RFP 2016-0009 - ADDENDUM 3

COLIGNY REDEVELOPMENT PROJECT

Town of Hilton Head Island, South Carolina

Date Issued: August 5, 2016

SHEET NUMBER
A1.402

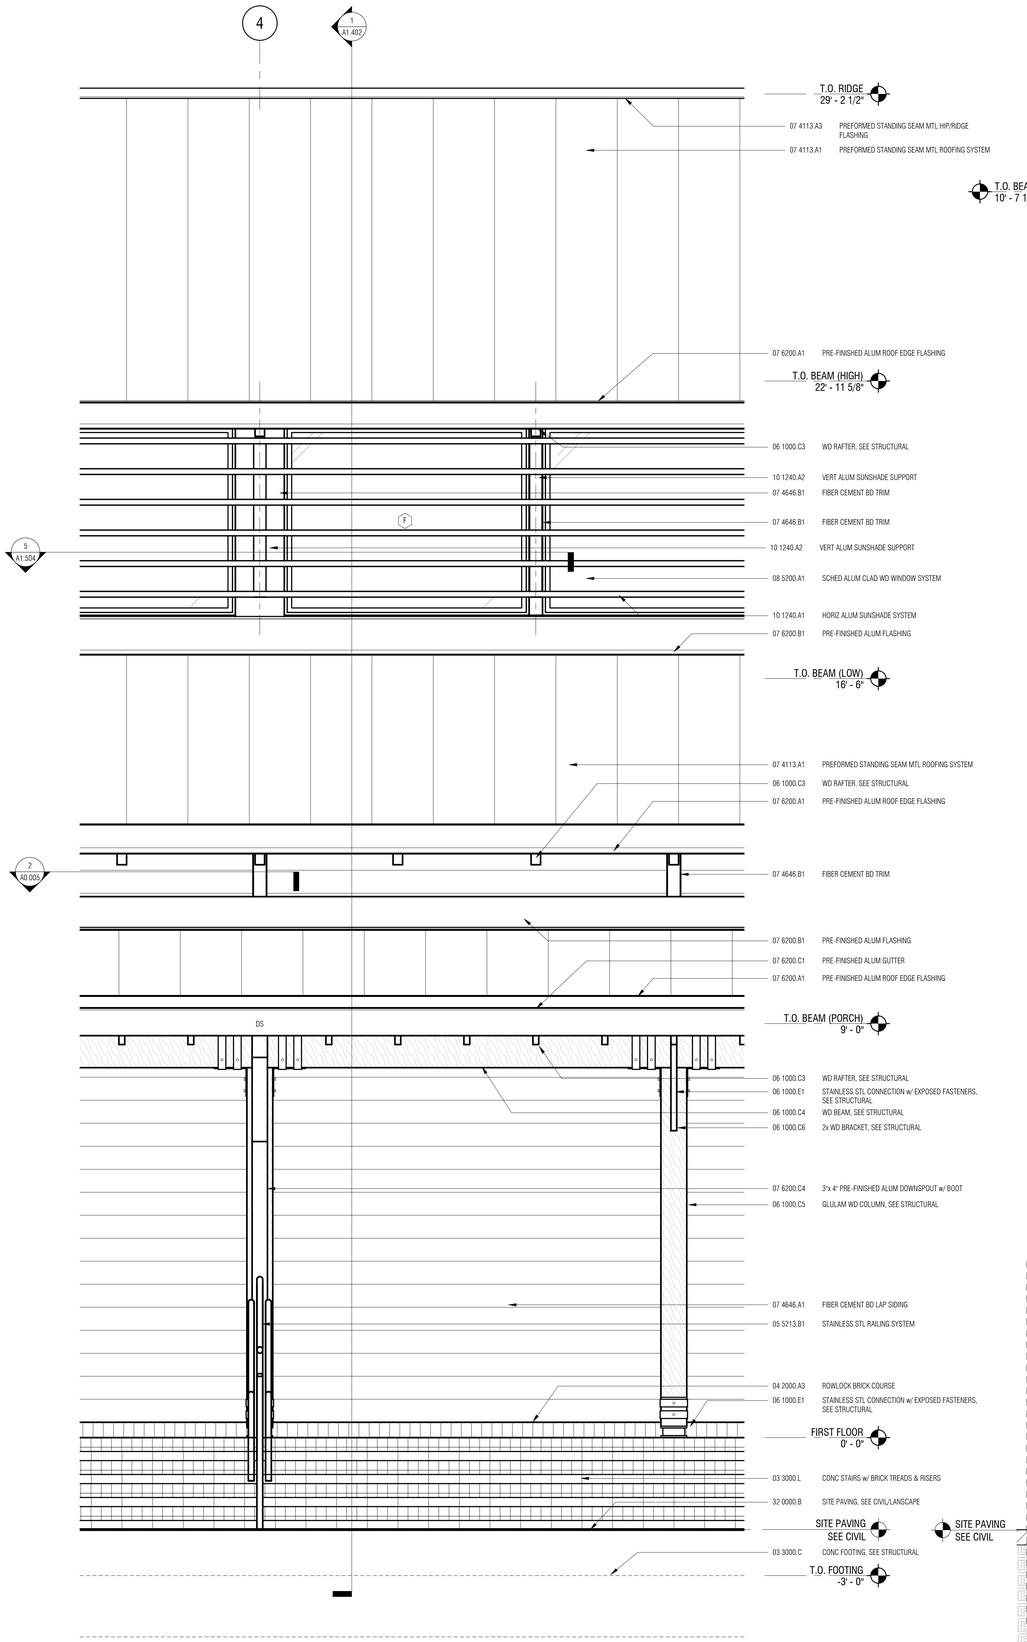
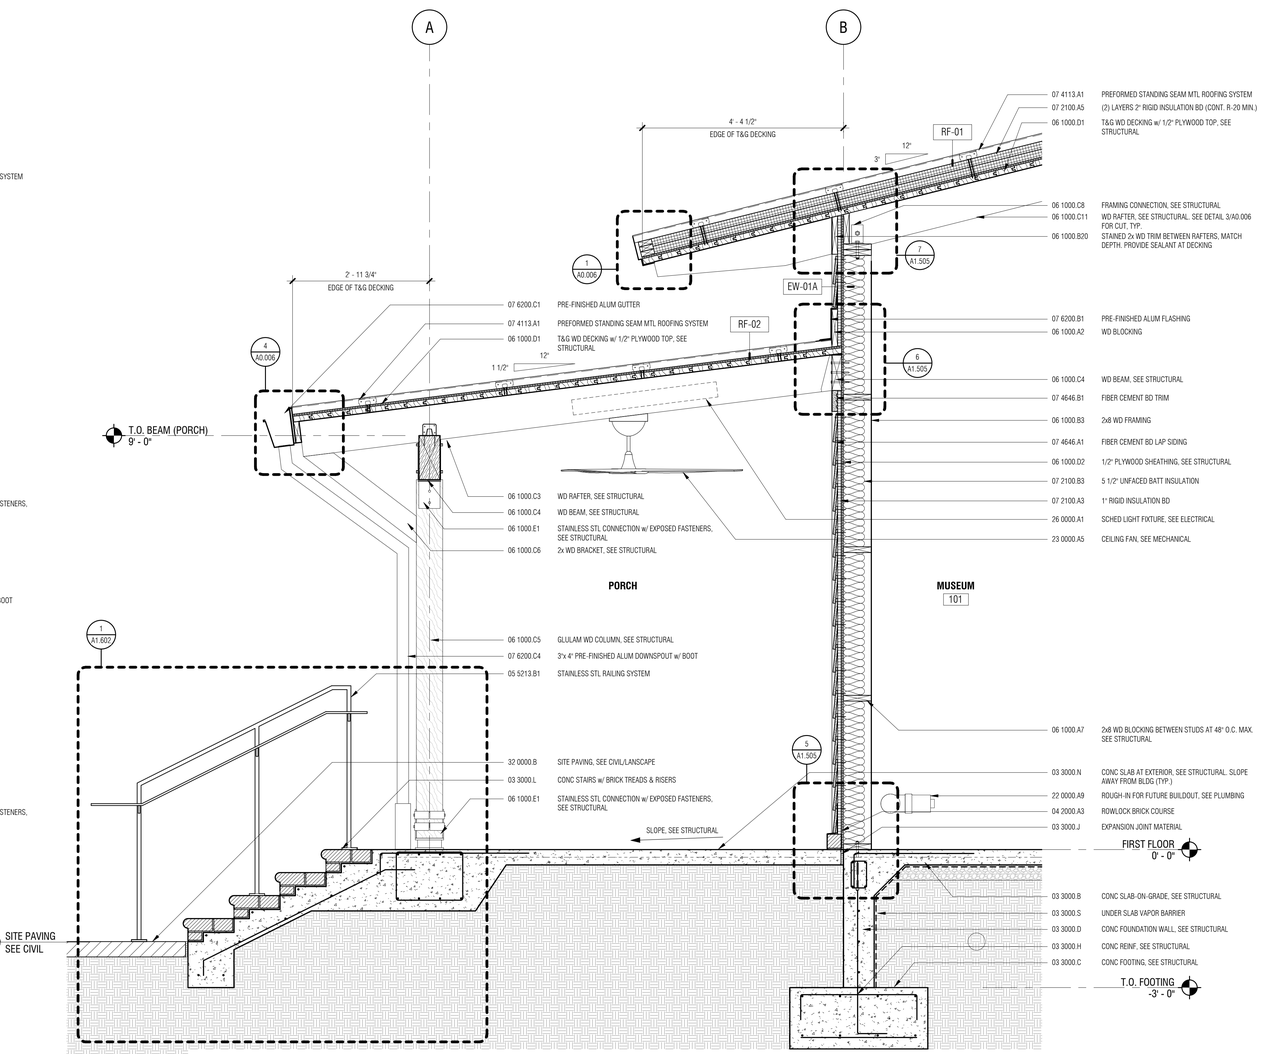
3.15 SHEET A1.402

A. Added Door 100A, stained wood trim, and gypsum wall board ceiling and framing at south entrance.

3 A1.404 WALL SECTION - NORTH
3/4" = 1'-0"

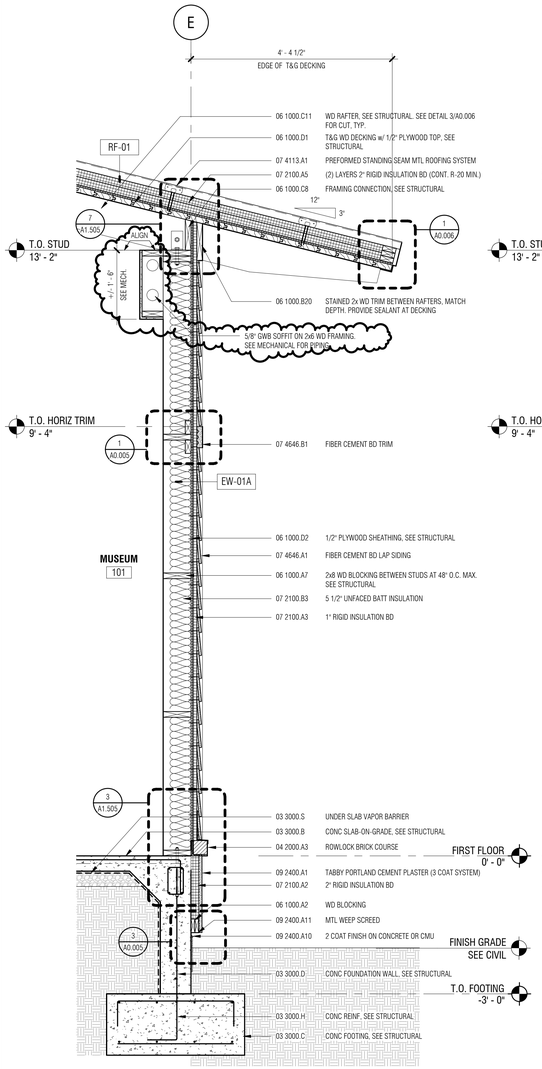
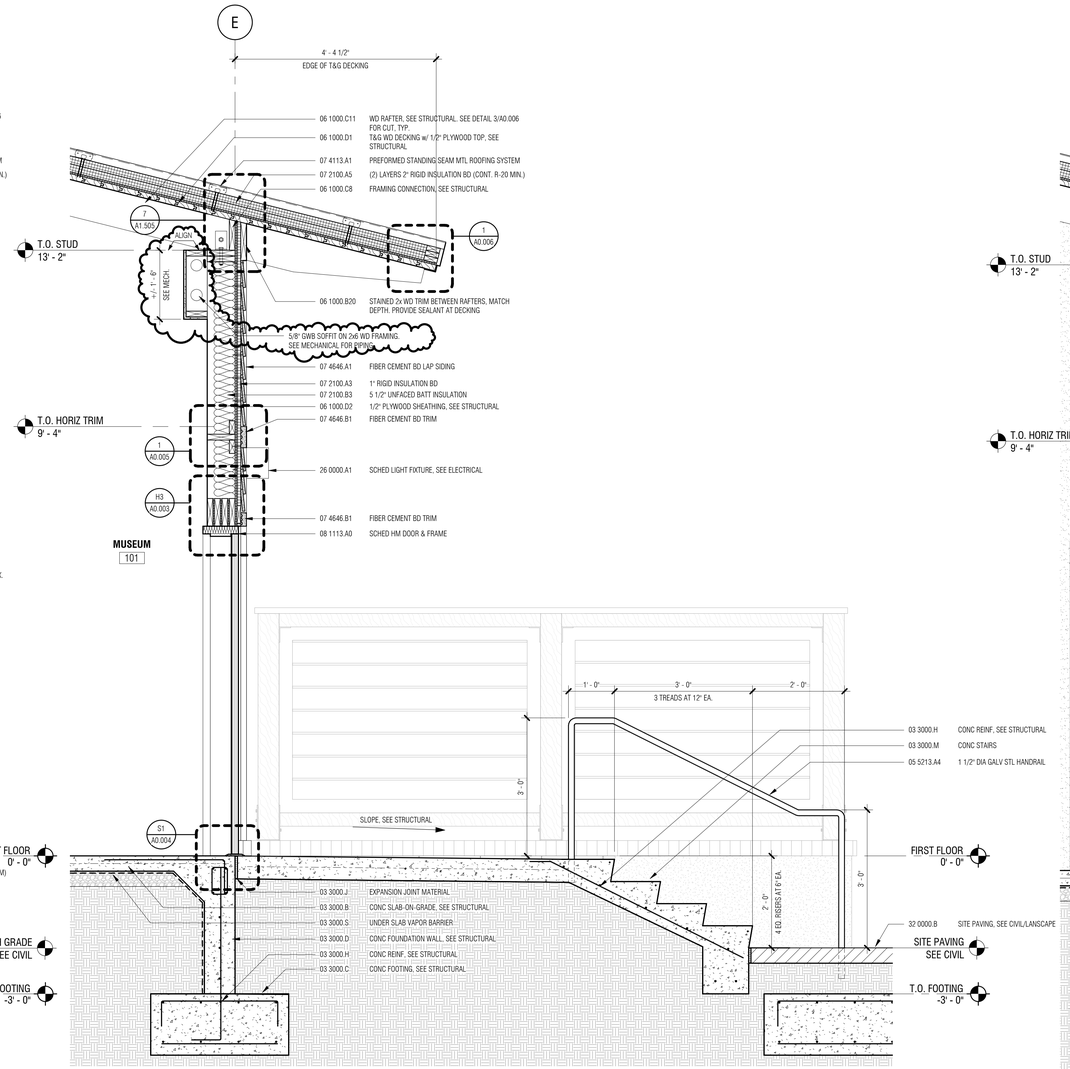
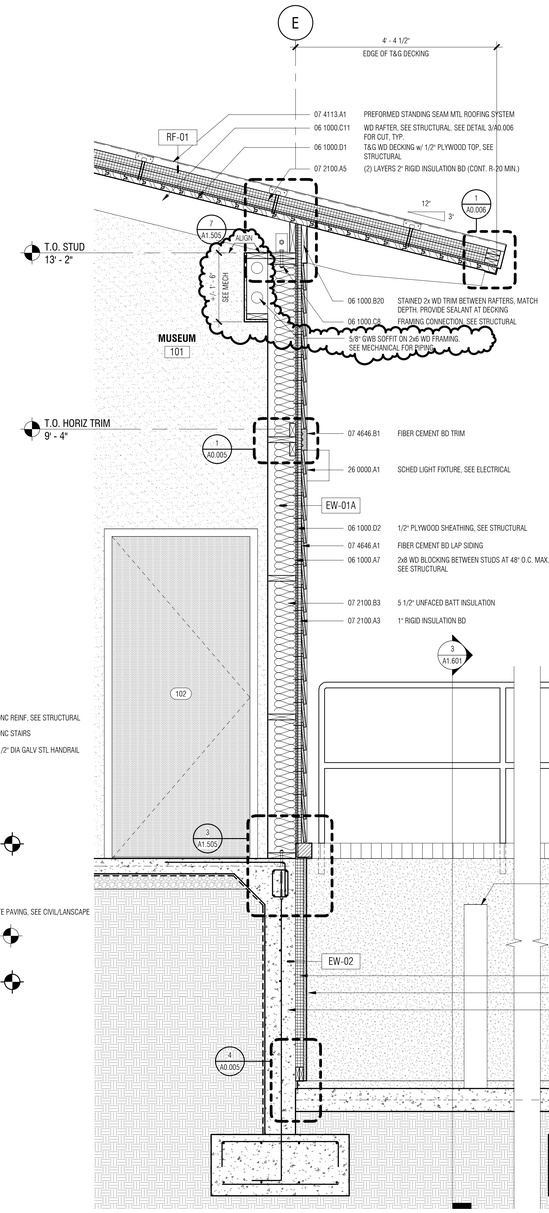
3.16 SHEET A1.404

A. Added gypsum wall board soffit at west exterior wall at mechanical
   1. piping.

2 A1.405 WALL SECTION - EAST ENTRANCE (WEST SIM.)
3/4" = 1'-0"

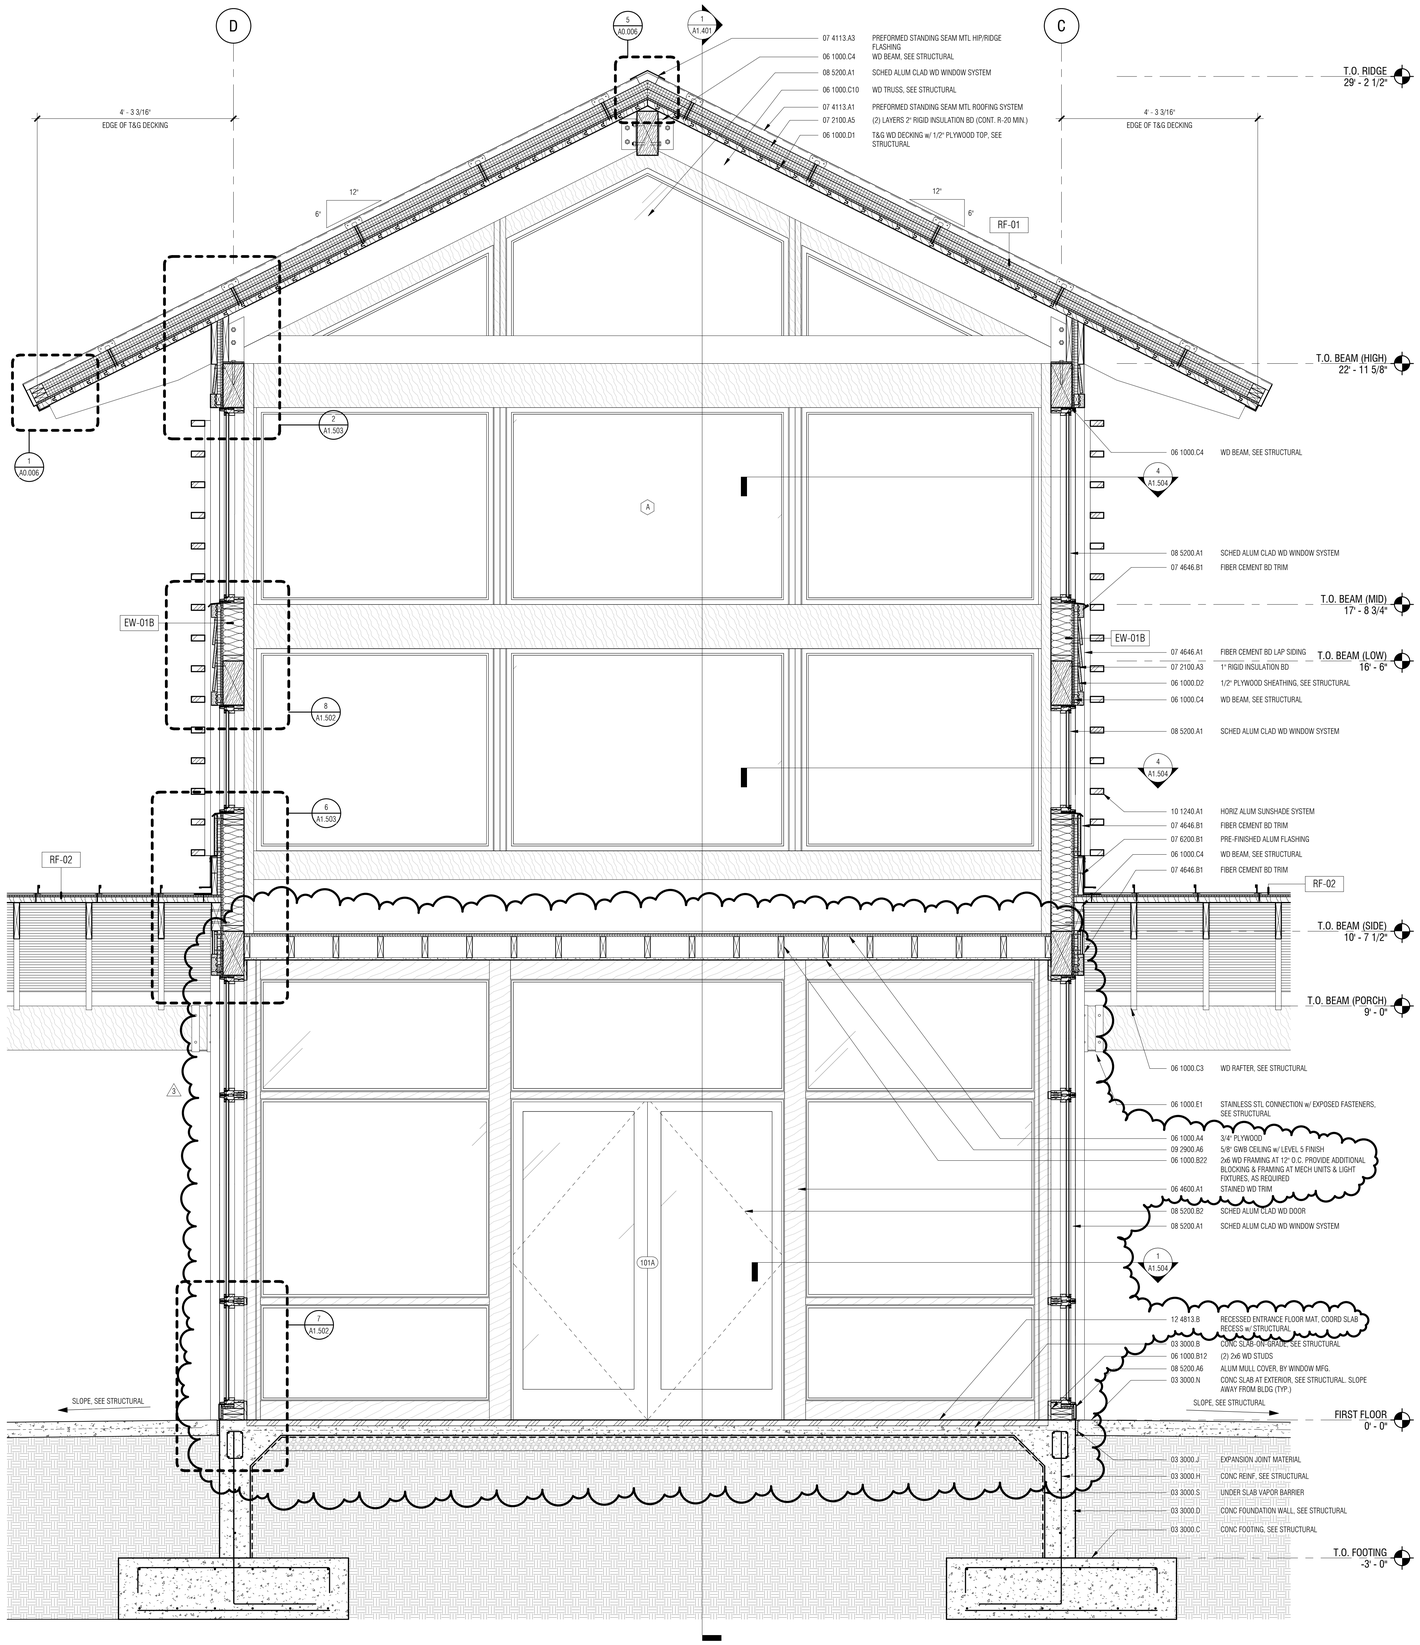
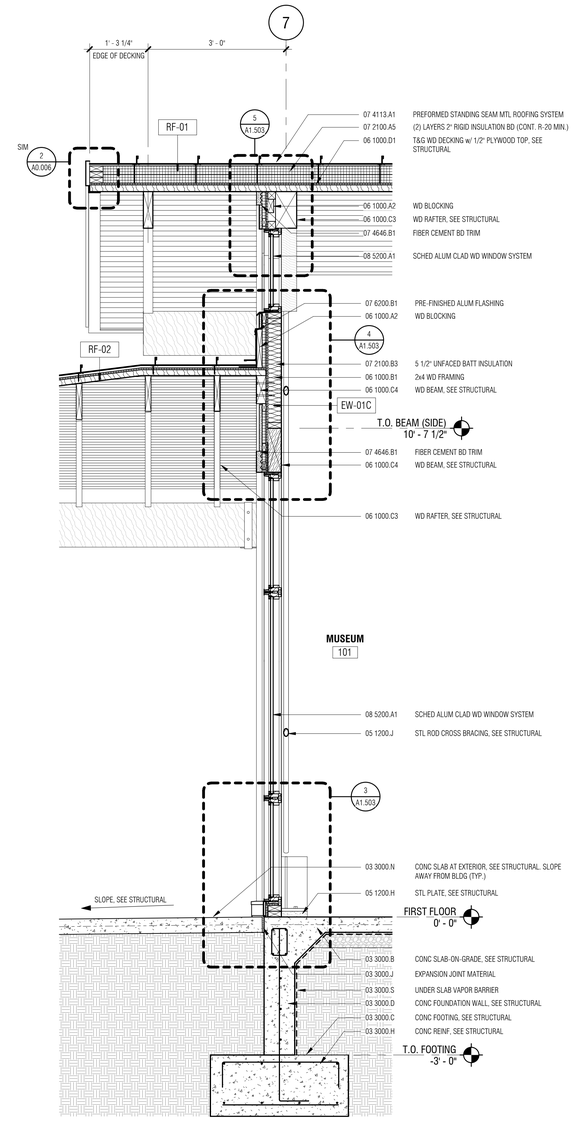
3.17 SHEET A1.405

A. Added Stained wood trim and gypsum wall board ceiling and framing at south entrance.
B. Add recessed entrance mat at entrance

3 / A1.502 WINDOW DETAIL - ENTRANCE BOTTOM
3" = 1'-0"

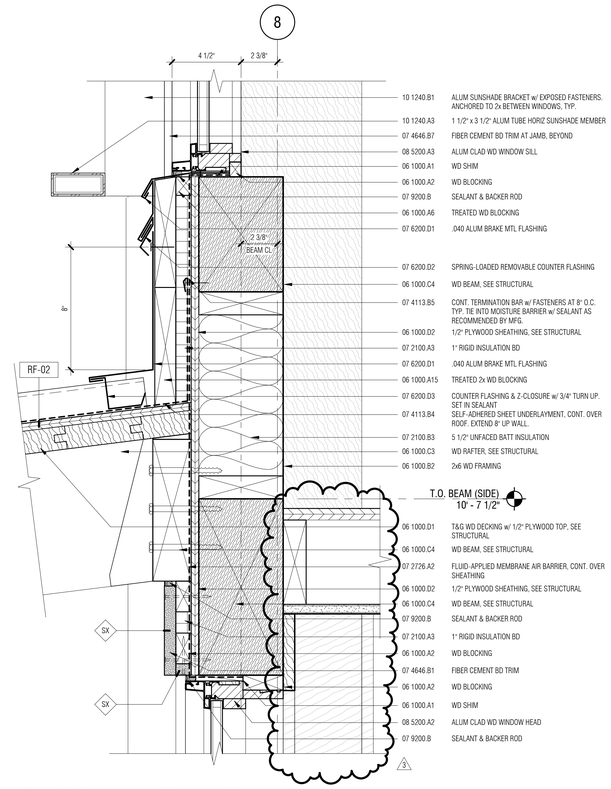
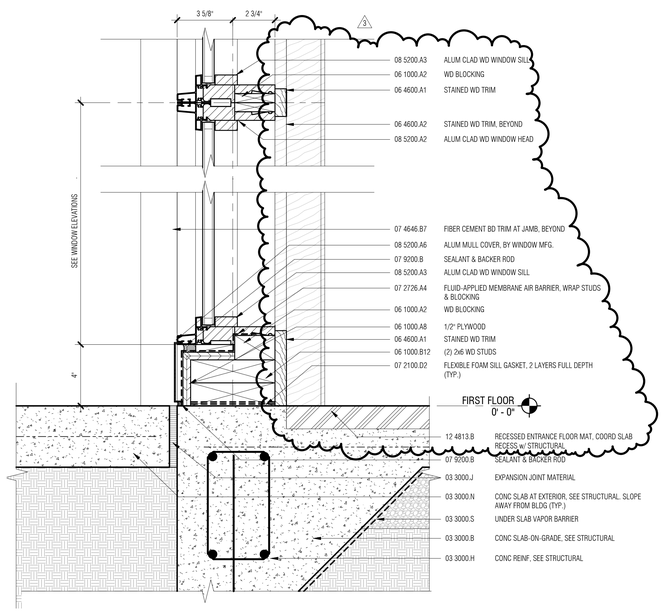
3.19 SHEET A1.502

A. Added stained wood trim and gypsum wall board ceiling and framing.
B. Add recessed entrance mat at entrance
